SERVICE BULLETIN

Flight Controls - Asymmetry Brake Assembly - Add Drain Holes

Hamilton Sundstrand Asymmetry Brake Assembly, Model FAS02AB, part number 763053, serial numbers 0001 through 0603, used on Bombardier Global aircraft.

Inseparable Housing Assembly Modification
Figure 1 (Sheet 1 of 2)

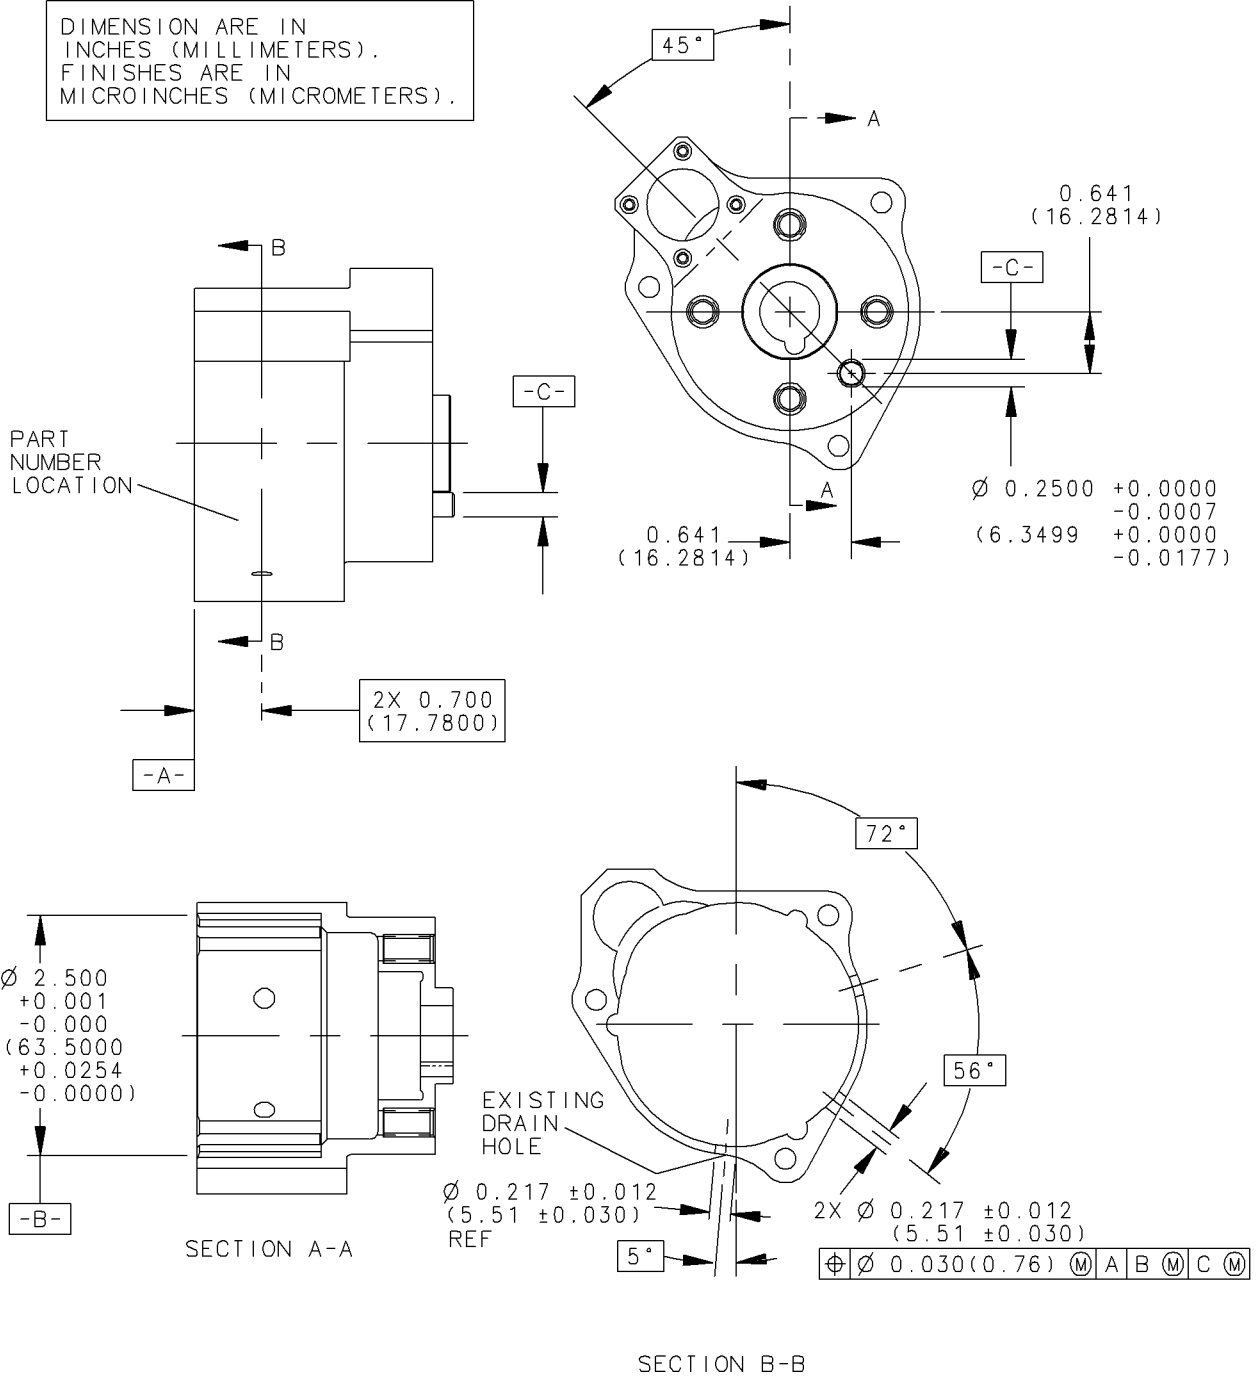
Field experience has shown that water can build up inside the asymmetry brake assembly when it is installed in certain positions on the aircraft. This is caused by the absence of multiple drain holes in the housing. The presence of the water can cause the asymmetry brake assembly to malfunction. Machining two additional drain holes in the housing will allow water to drain when installed in any position on the aircraft and reduce malfunctions. Incorporation of this bulletin will improve the reliability of the asymmetry brake assembly.

- (1) Modify the inseparable housing assembly (30) (refer to Figure 1 of this bulletin).

1. Locate and drill two 0.217 ± 0.012 inch (5.51 ± 0.030 millimeter) drain holes (refer to the view).
2. Deburr the machined areas.
3. Clean the housing (refer to SPM 20-00-00, CLEANING).
4. Change the part number from 763965 to 1701855 (refer to the view and SPM 20-00-00, ASSEMBLY).
5. Apply chemical conversion coating to the machined areas and to the area where the part number was changed (refer to the view and SPM 20-00-00, REPAIR).
6. Touch up paint as needed (refer to CMM 27-52-53, ASSEMBLY).
